FARRAGUT VISUAL RESOURCES REVIEW BOARD

MEMORANDUM

TO: Farragut Visual Resources Review Board
FROM: Bart Hose, Assistant Community Development Director
SUBJECT: Regularly Scheduled Meeting - Tuesday, January 22, 2019 at 7:00 p.m.

BRASS LANTERN
ENTRY SIGNAGE CONSTRUCTION SET

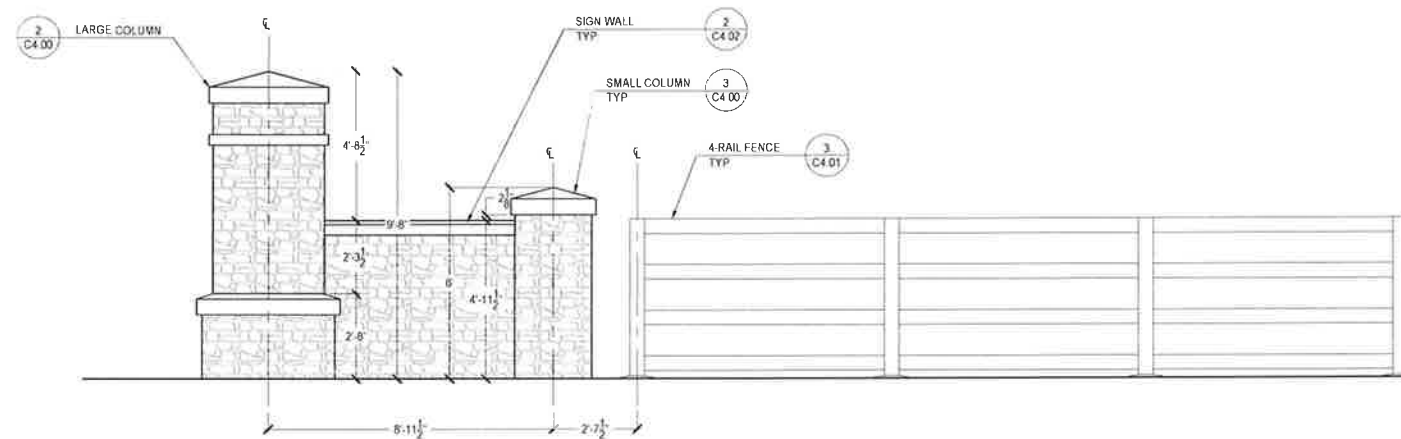
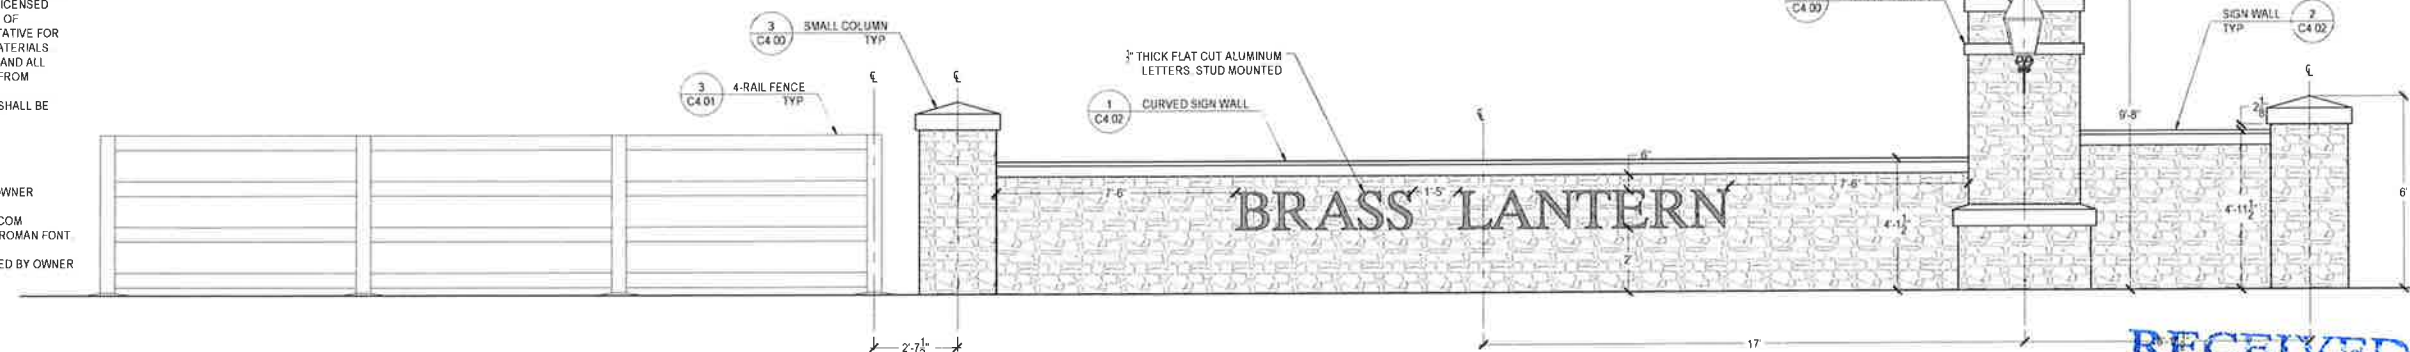
Brass Lantern Subdivision is requesting approval for construction of a permanent subdivision entrance sign located at 801 McFee Road. The Town's staff has identified several issues or questions regarding the submitted plans. This includes the following:

1. The sign and structure violate the Town's required 10-foot setback standards (10 feet from all property lines).
2. The dimensions of the sign (message component) are not clearly provided in conformance with Town standards.
3. The proposed spot-lights may require additional cut-off shields to comply with the Town's lighting standards.
4. The location of the proposed sign and other revised plan elements conflict with the previously approved landscaping plan for the development. The approved landscaping plan will need to be revised to reflect sign location and other revised plan elements, including the mail facility.

5. No previously submitted plan or plat sheets reflect the relocation of site lighting (pole) elements to the median island. Revised plan/plat sheets will be required.
6. Any sign easement(s) required to accommodate the sign will have to be added to overall subdivision plat.
7. Property/ROW and easement lines should be labeled on all sheets and setback distances from all property/ROW lines must be clearly identified on all sheets.

The staff has discussed these issues with the applicant's design professionals and they plan to reduce the size of lot 30 and increase the size of the open space lot to address the setback issues. They are also aware that the signage plan will require adjustments to the subdivision plat and a revised landscaping plan. A final subdivision plat is now scheduled to be reviewed by the Planning Commission in February.

The staff has asked the applicants to submit a revised plan addressing the noted issues prior to the meeting. Any approval of the entrance sign plan should be made subject to all noted issues being addressed in a satisfactory manor, and all related changes to the subdivision plat and landscaping plan being formally made and approved. This includes submission of the revised landscaping plan to the Board for review.

C4.01 - SITE DETAILS

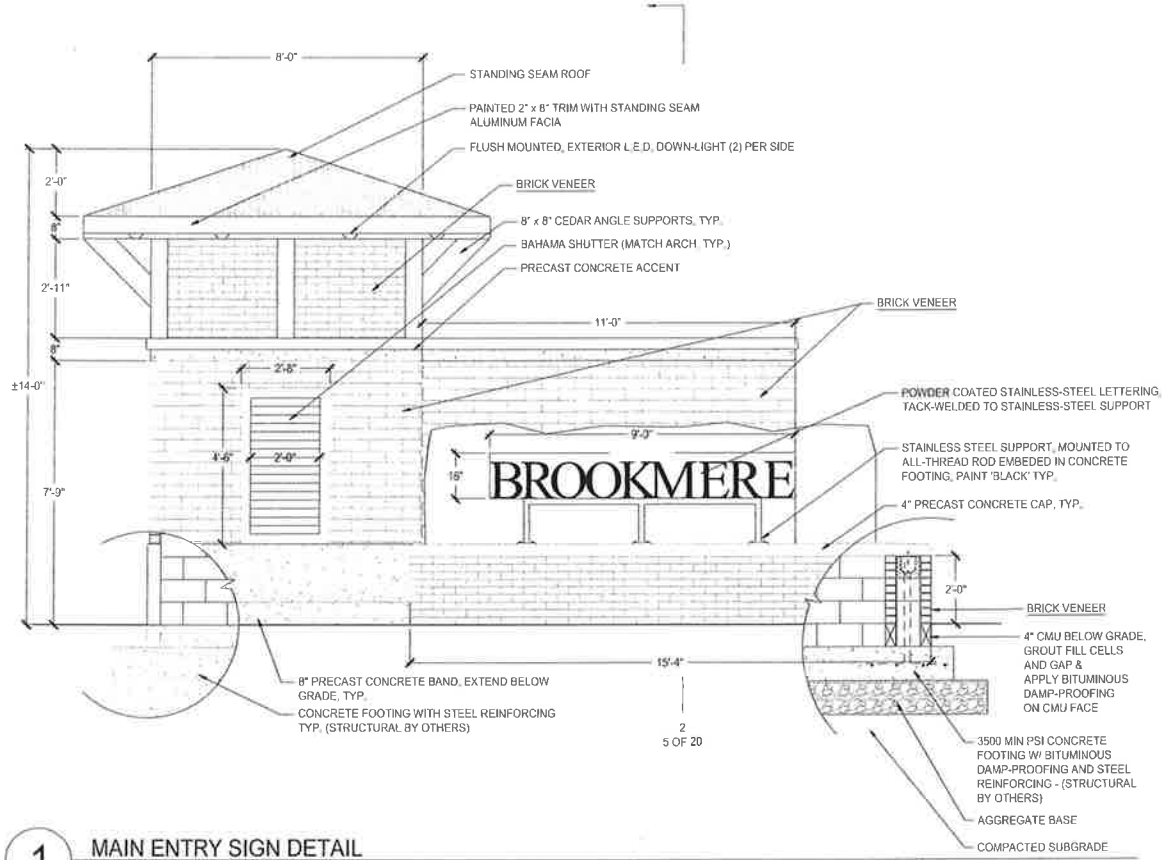
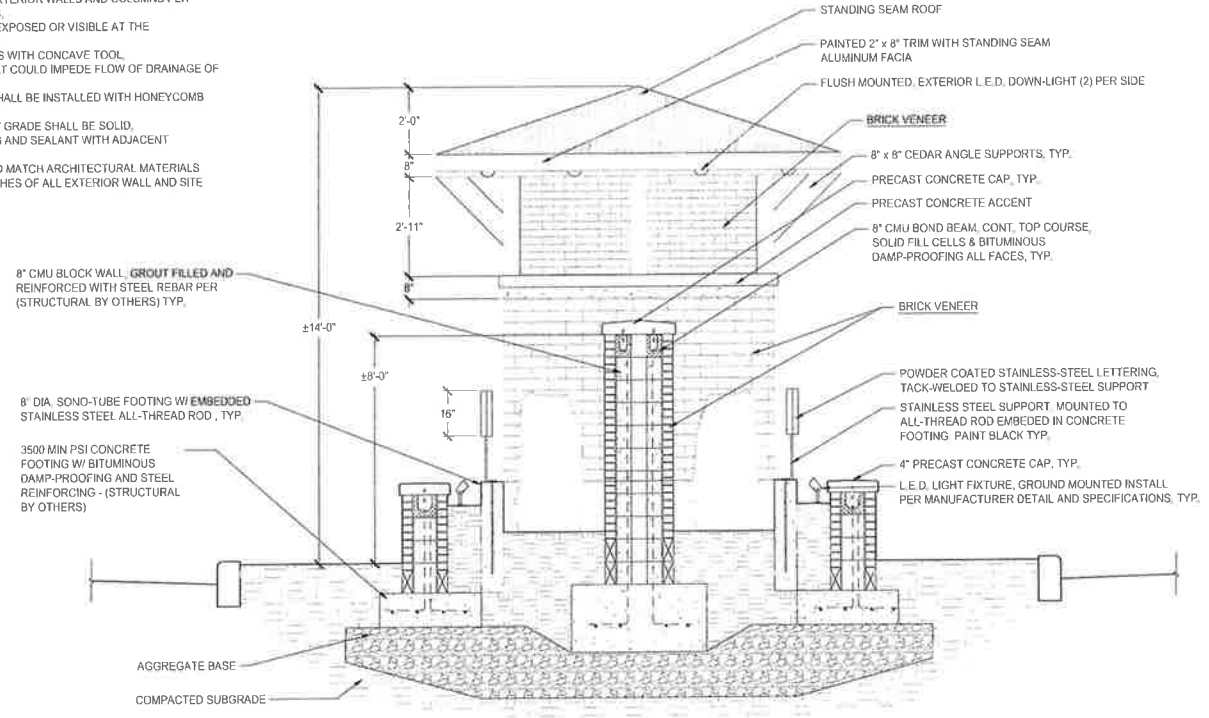
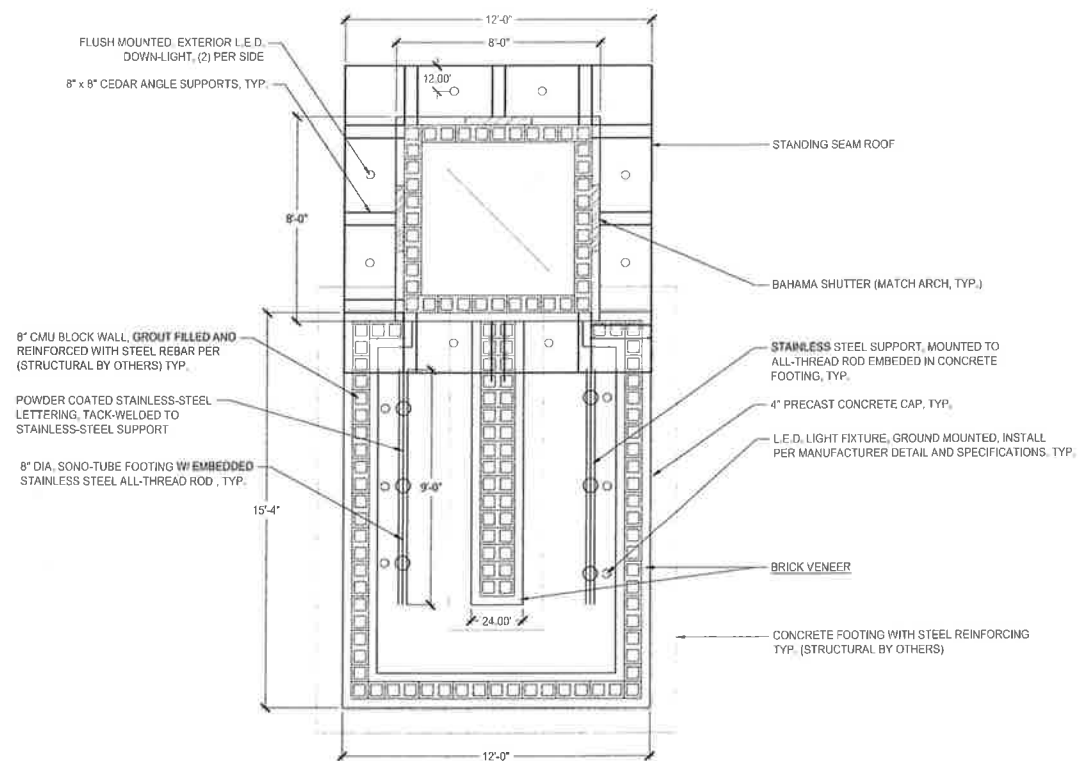
Brookmere Subdivision is requesting approval for construction of a permanent subdivision entrance sign located at 430 Virtue Road. The sign and entranceway structure will be located in a median island within Needlegrass Lane (proposed). The location within the road right-of-way has been approved by the Board of Mayor and Aldermen. The proposed sign actually includes two separate signs, one located on each side of the median and entranceway structure. Each sign totals 12 square feet in area, which falls within the Town's size requirements. Please also note that the project's landscaping plan (see next agenda items) includes the proposed entrance sign.

The staff recommends approval subject to the following issues being satisfactorily addressed;

1. Clearly documenting that the sign(s) does not exceed the Town's 6-foot maximum height requirement;
2. The inclusion of all light fixture cut-sheet details on the applicable plan sheets and ensuring that each fixture is keyed and clearly located on the plan;
3. Field verification, by staff, that the lighting plan conforms with Town standards;
4. The installed location and height of the sign(s) being field verified by a surveyor.
